**BROWNS FERRY NUCLEAR PLANT (BFN) – UNITS 1, 2, AND 3 – TECHNICAL SPECIFICATIONS (TS) CHANGES TS-431 AND TS-418 – EXTENDED POWER UPRATE (EPU) – RESPONSE TO REQUEST FOR INFORMATION REGARDING CONTAINMENT PARAMETERS FOR NRC CONFIRMATORY ANALYSIS (TAC NOS. MD5262, MD5263, AND MD5264)**

#### RESPONSE TO REQUEST FOR INFORMATION REGARDING CONTAINMENT PARAMETERS FOR NRC CONFIRMATORY ANALYSIS

Figure 1

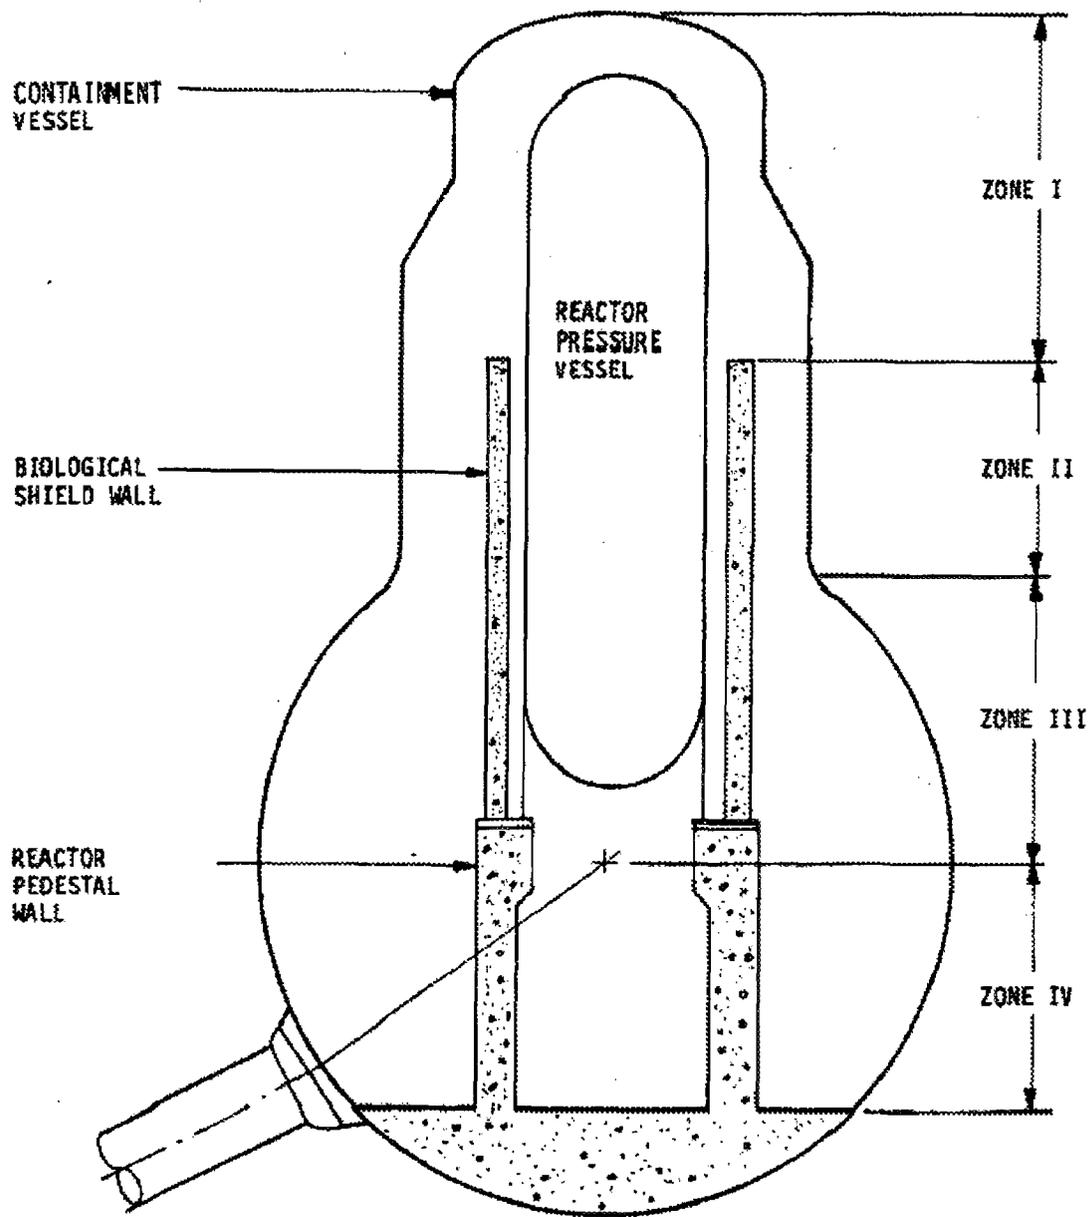
- a. Liquid vapor interface area in reactor vessel;
- b. Data for heat sinks (material, mass, and surface area) in drywell (DW), wetwell (WW) airspace, and suppression pool);
- c. Size of each vacuum breaker pipe and its length between WW and DW;
- d. Reactor pressure vessel (RPV) metal thickness (average if it varies);
- e. Elevations of suppression pool low and high water level;
- f. Elevations of vacuum breaker line inlet (in WW) and outlet (in DW) area center;
- g. Elevations of core spray (CS) suction line, and residual heat removal (RHR) suction line at the suppression pool;
- h. For Appendix R event analysis, provide the heat removal rate by each drywell fan cooler.

- a. The vessel fluid (liquid water and vapor) in the General Electric - Hitachi (GEH) containment codes (M3CPT and SHEX) is modeled as a single fluid node. It is assumed at all times that the vessel liquid and vessel vapor are in thermodynamic equilibrium with each other at a saturation condition corresponding to the vessel pressure and temperature. Since thermodynamic equilibrium between the vessel vapor and liquid is imposed in the calculation, heat and mass transfer between the vessel liquid and vapor is not mechanistically modeled and a liquid-vapor interface area in the reactor vessel is not used in the GEH containment analysis.
- b. Tables 1, 2, and 3 provide the heat sink data compiled for use in the EPU containment analyses for BFN Units 1, 2, and 3.

1. See Figure 1 for drywell zones identification.
2. Exposure –
  - 1 = Drywell atmosphere
  - 2 = Wetwell atmosphere
3. Mass calculated as the Total Surface Area \* Shell Thickness \* Density (Table 3).
